Wiggins - I-76 MM 66
Elevation \approx 4500'

CDOT Region #4

Summary Observations

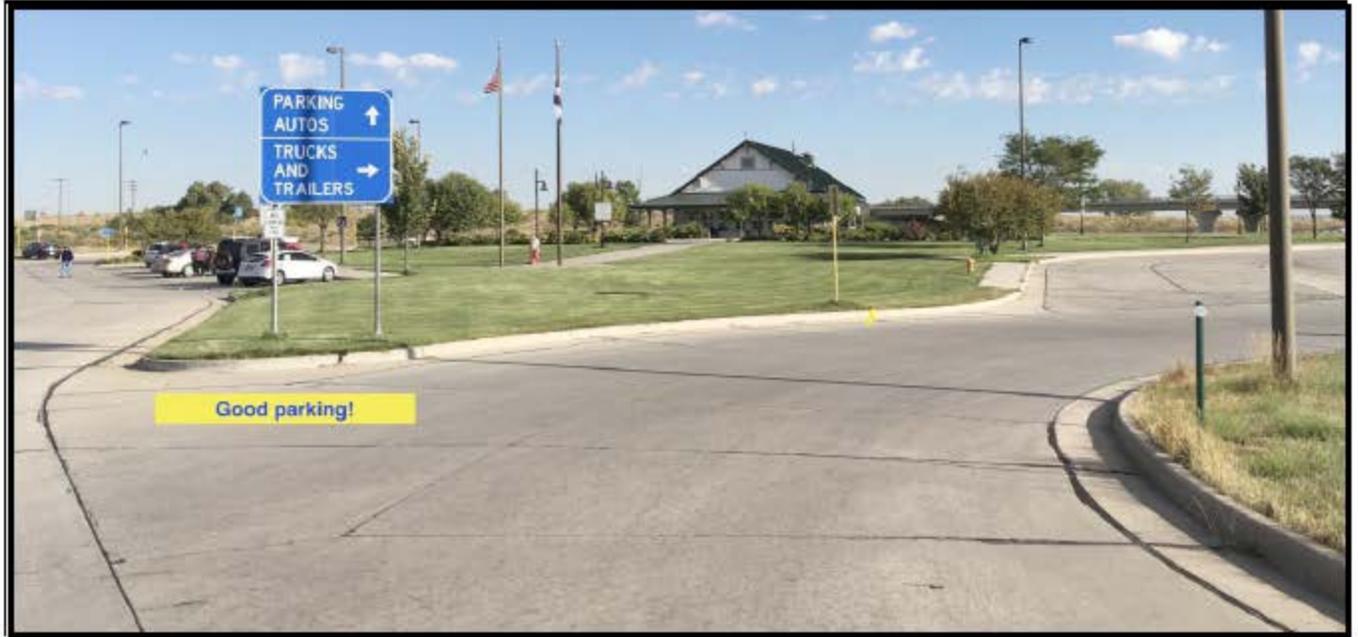
Good 'family' restrooms

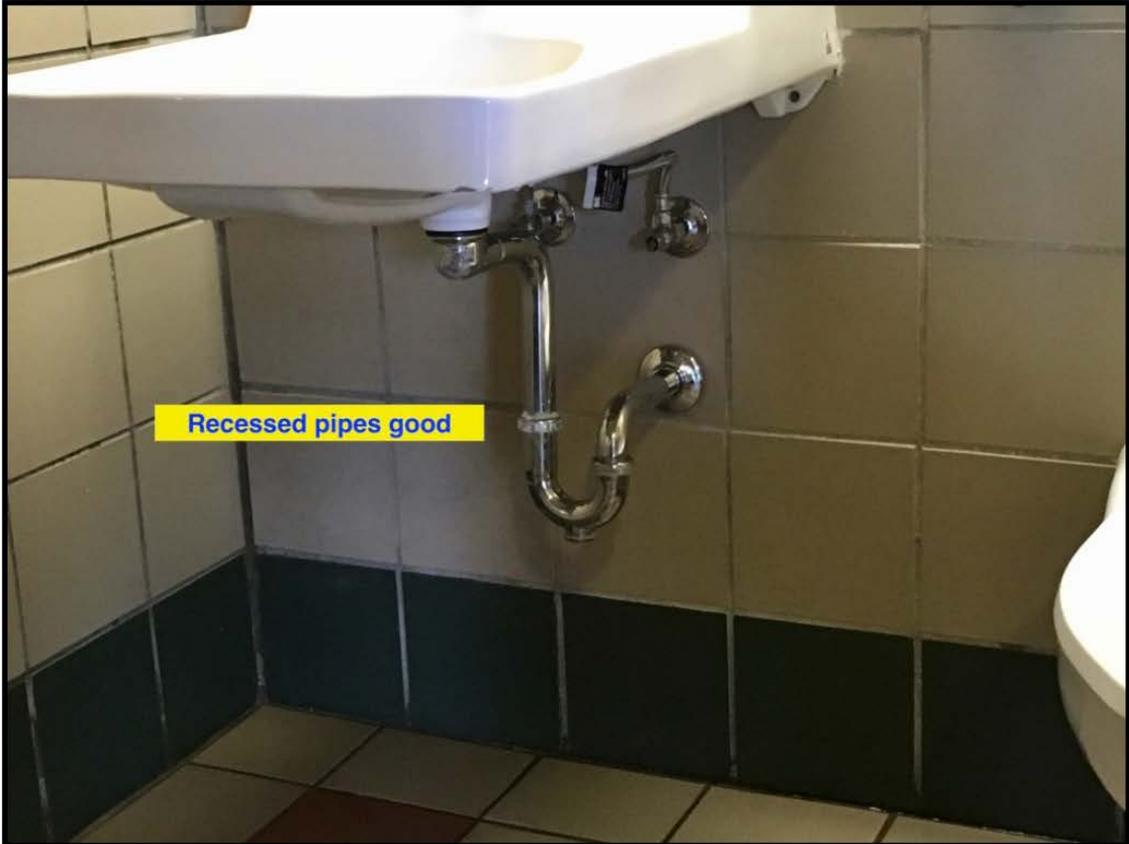
Recessed pipes good
